**AMENDMENT C CHANGES. SHOWN CLOUDED.**

**DEVELOPMENT APPLICATION SUBMISSION FOR:**

## 41 & 43 BEACH ROAD,COLLAROY, 2097
## LOT 1 DP300846 & LOT 2 SEC 7 DP7391

**GF level**

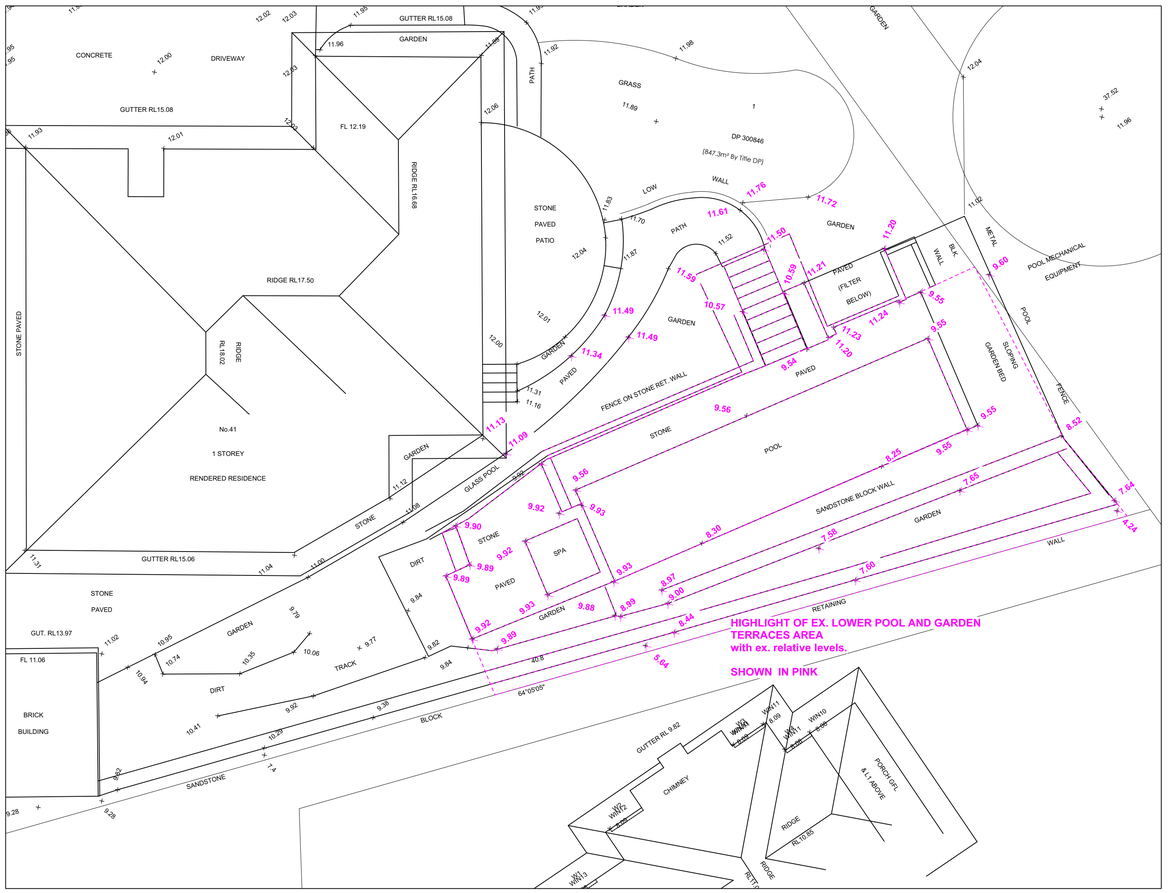
8.21 sqm
Area non-compliant with DCP - B1 "maximum wall height" (7.2 m above ex.ground level) regulation.
Height above 7.2 m control = 0.4 m at the highest point. 0.2 m as average.
Area directly above the ex. pool excavation.
Shown shaded in yellow.
Refer to section H-H'

DRAWING TITLE
ANALYSIS OF PROPOSAL
AGAINST DCP B1 "WALL HEIGHT" & B3 "SIDE ENVELOPE" CONTROLS
PARTIAL SECTIONS B-B', W-W' (POINT "D-2") & Z-Z' (POINT "D")
INTERNAL AREAS SHADED

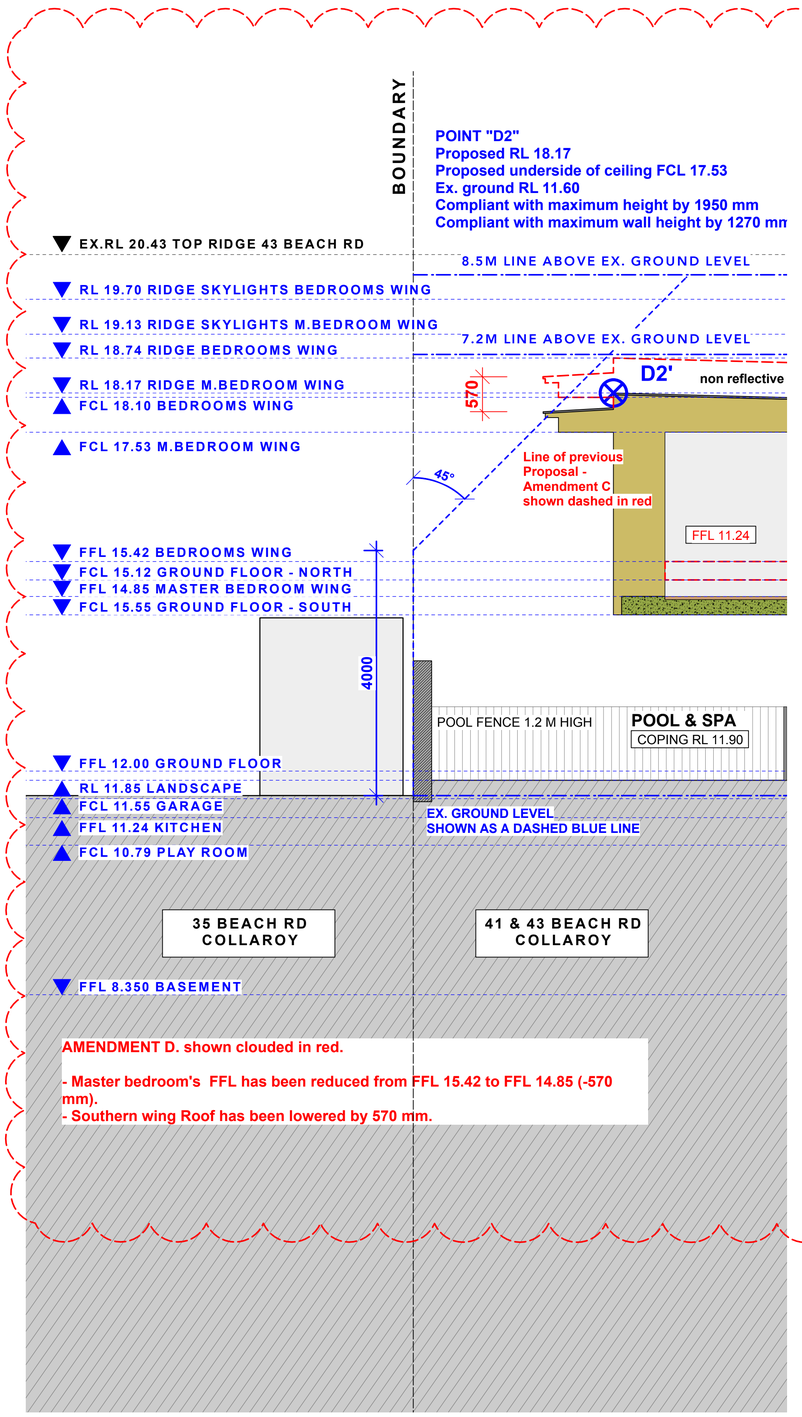
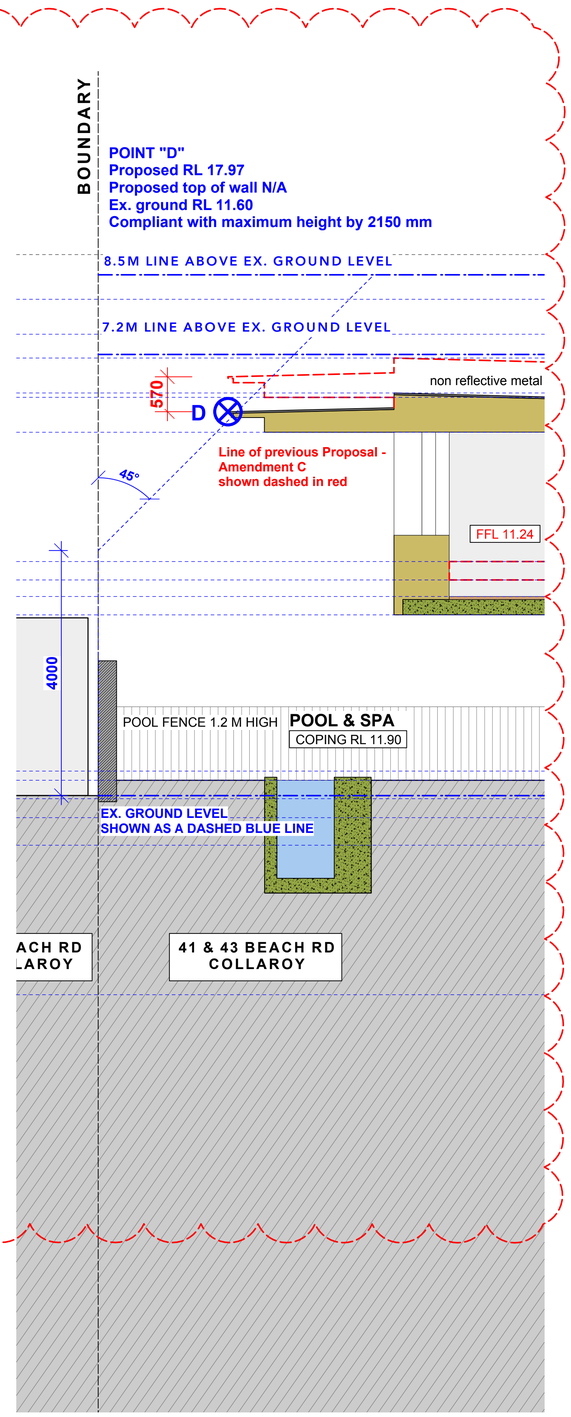
- Base of southern boundary wall has been updated with the relative levels shown on survey prepared by Norton Survey Partners.
- Side Envelopes related to Warringah's DCP-B3 "Side Envelope" control have been updated on proposed sections and elevations using the survey prepared by Norton Survey Partners.
- GF southern wall has been moved 500 mm to the North.
- FF southern wall has been moved to the North between 300 mm to 610 mm.
- Kitchen southern wall & roof to be built on an angle to comply with DCP – B3 "Side Envelope" control.
- Kitchen's FFL has been reduced from FFL 12.00 to FFL 11.24 (-760mm).
- Master bedroom's FFL has been reduced from FFL 15.42 to FFL 14.85 (-570 mm).
- Southern wing Roof has been lowered by 570 mm.
- Basement southern area has been updated to match new proposal.
- GF's roof has been updated to match new proposal.

AMENDMENT D. shown clouded in red.

- Master bedroom's FFL has been reduced from FFL 15.42 to FFL 14.85 (-570 mm).
- Southern wing Roof has been lowered by 570 mm.

**01** **SECTION A-A'**

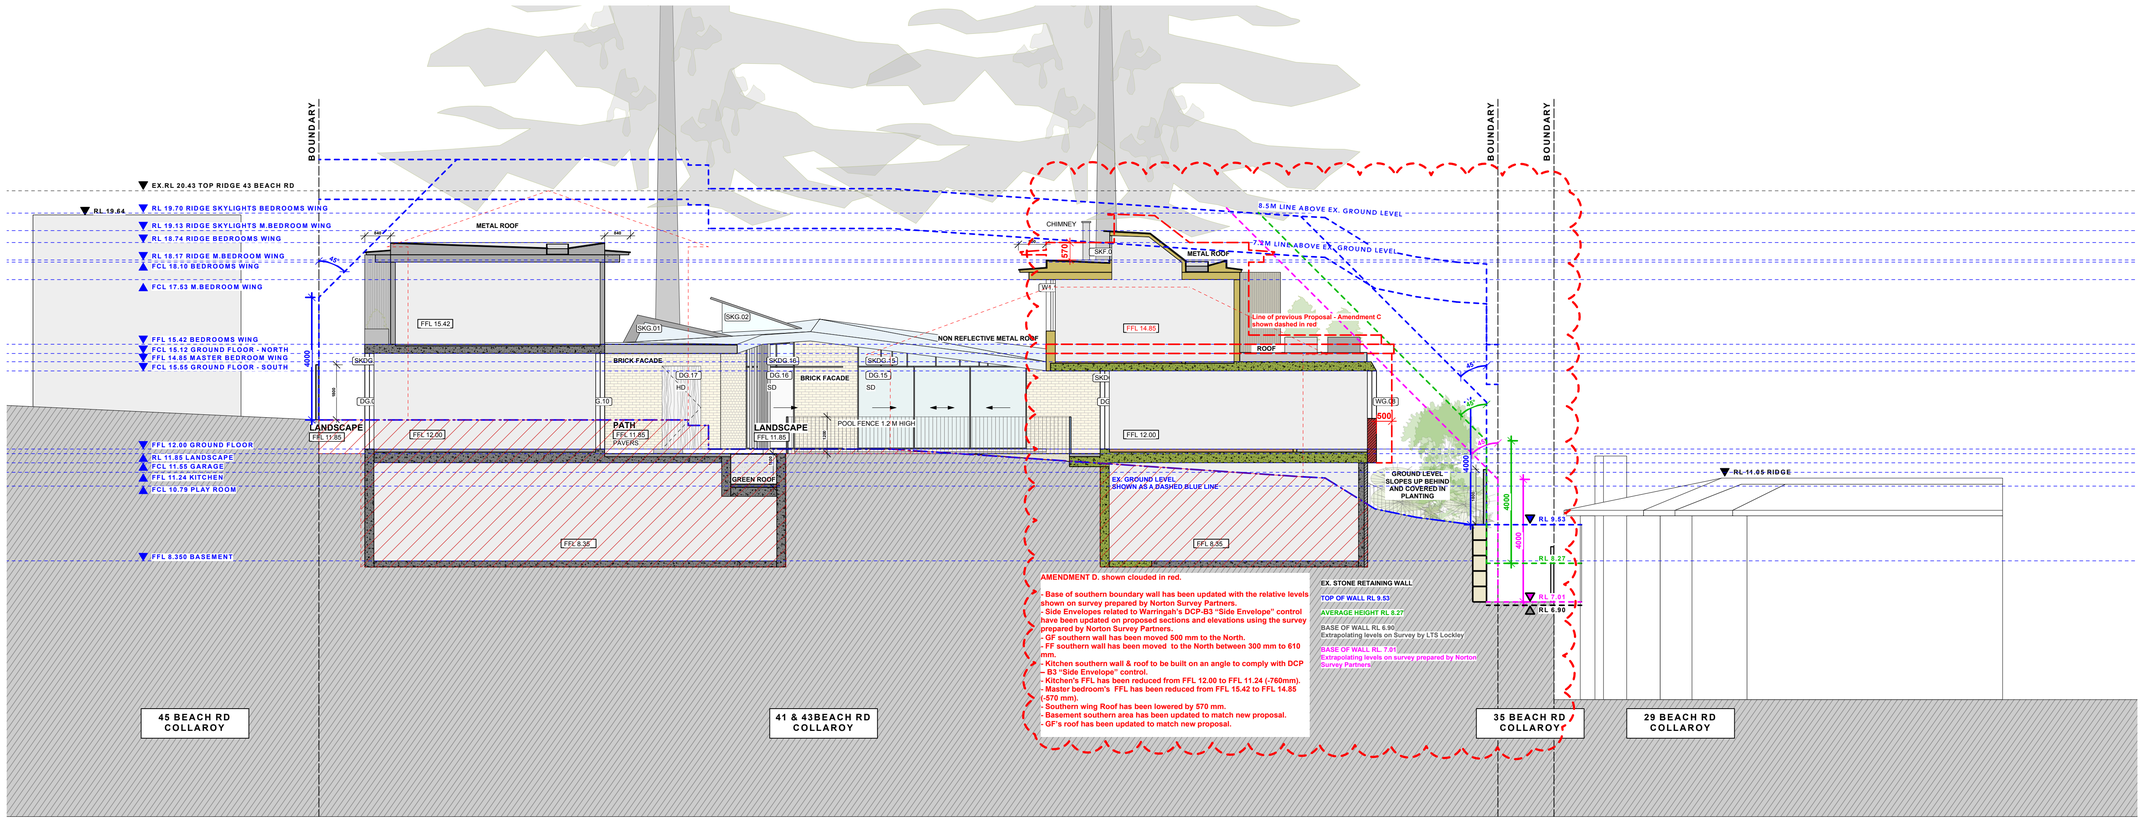
**AMENDMENT D. shown clouded in red.**
- Base of southern boundary wall has been updated with the relative levels shown on survey prepared by Norton Survey Partners.
- Side Envelopes related to Warringah's DCP-B3 "Side Envelope" control have been updated on proposed sections and elevations using the survey prepared by Norton Survey Partners.
- GF southern wall has been moved 500 mm to the North.
- FF southern wall has been moved to the North between 300 mm to 610 mm.
- Kitchen southern wall & roof to be built on an angle to comply with DCP – B3 "Side Envelope" control.
- Kitchen's FFL has been reduced from FFL 12.00 to FFL 11.24 (-760mm).
- Master bedroom's FFL has been reduced from FFL 15.42 to FFL 14.85 (-570 mm).
- Southern wing Roof has been lowered by 570 mm.
- Basement southern area has been updated to match new proposal.
- GF's roof has been updated to match new proposal.

DRAWING TITLE
PROPOSED ELEVATION SHADOWS OVER 29 BEACH RD. NORTHERN FACADE
SHADOW DIAGRAMS AT 9AM, 12PM & 3PM-21ST JUNE

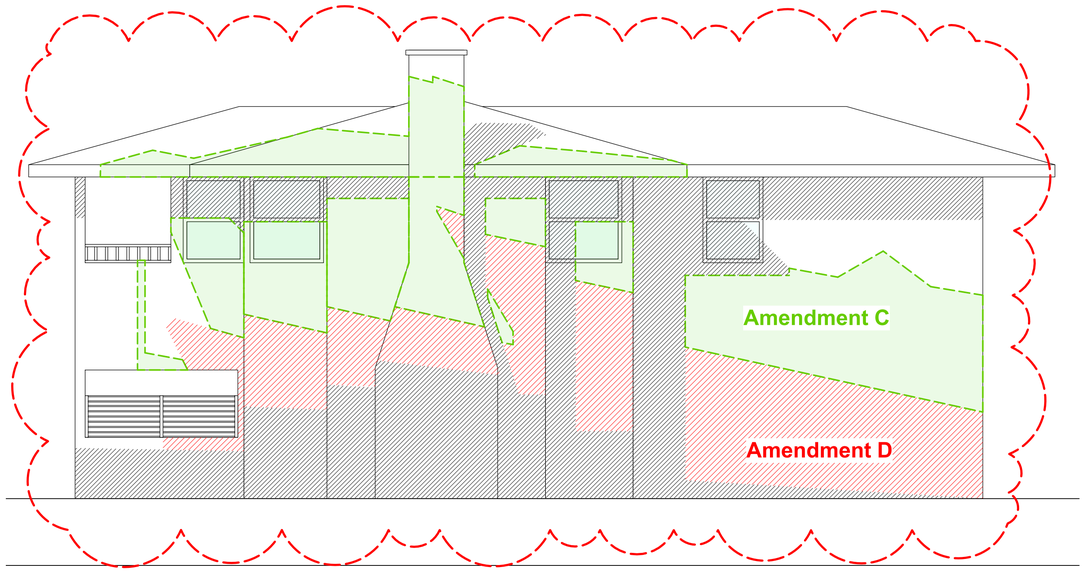
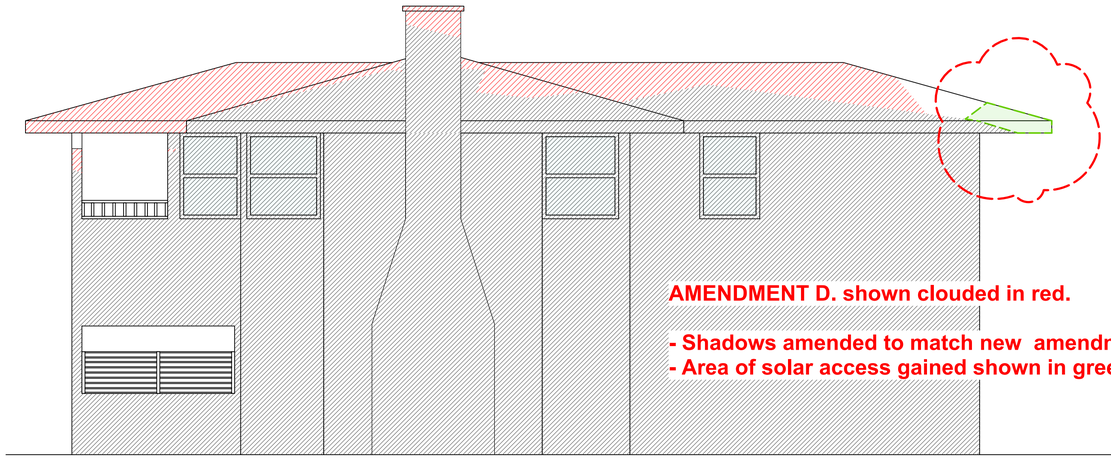
**AMENDMENT D. shown clouded in red.**

**- Shadows amended to match new amendment D proposal**
**- Area of solar access gained shown in green**

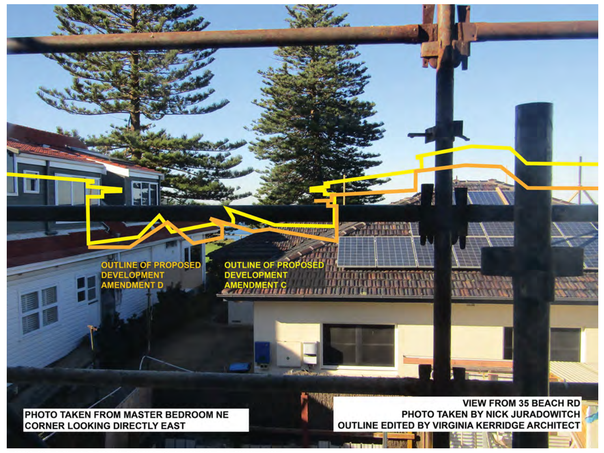
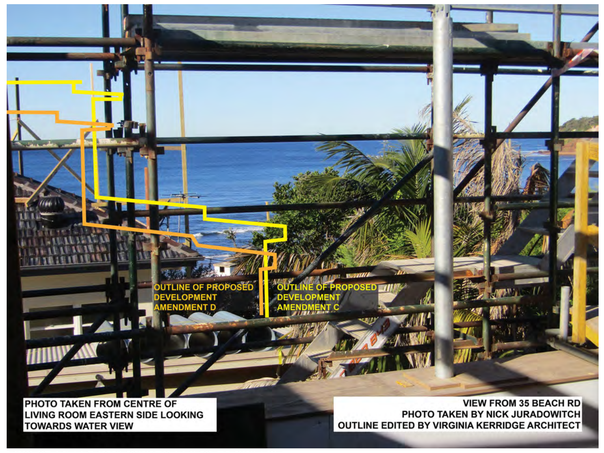
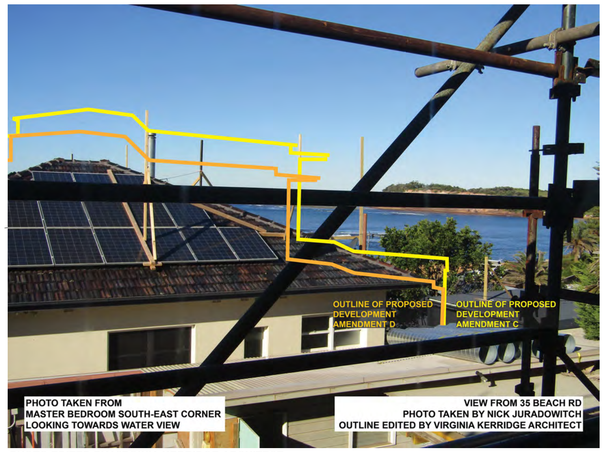
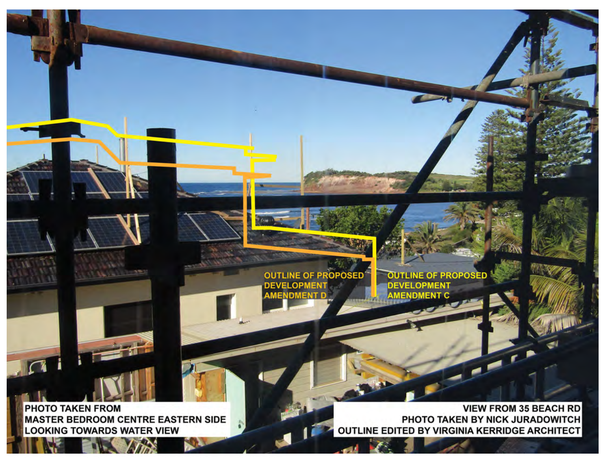
*PHOTO EDITED BY VIRGINIA KERRIDGE ARCHITECT.*
*OUTLINE OF PREVIOUS PROPOSED DEVELOPMENT SHOWN AS A YELLOW LINE - AMENDMENT C*
*OUTLINE OF CURRENT PROPOSED DEVELOPMENT SHOWN AS AN ORANGE LINE - AMENDMENT D*

*PHOTO EDITED BY VIRGINIA KERRIDGE ARCHITECT.*
*OUTLINE OF PREVIOUS PROPOSED DEVELOPMENT SHOWN AS A YELLOW LINE - AMENDMENT C*
*OUTLINE OF CURRENT PROPOSED DEVELOPMENT SHOWN AS AN ORANGE LINE - AMENDMENT D*

*PHOTO EDITED BY VIRGINIA KERRIDGE ARCHITECT.*
*OUTLINE OF PREVIOUS PROPOSED DEVELOPMENT SHOWN AS A YELLOW LINE - AMENDMENT C*
*OUTLINE OF CURRENT PROPOSED DEVELOPMENT SHOWN AS AN ORANGE LINE - AMENDMENT D*

*PHOTO EDITED BY VIRGINIA KERRIDGE ARCHITECT.*
*OUTLINE OF PREVIOUS PROPOSED DEVELOPMENT SHOWN AS A YELLOW LINE - AMENDMENT C*
*OUTLINE OF CURRENT PROPOSED DEVELOPMENT SHOWN AS AN ORANGE LINE - AMENDMENT D*
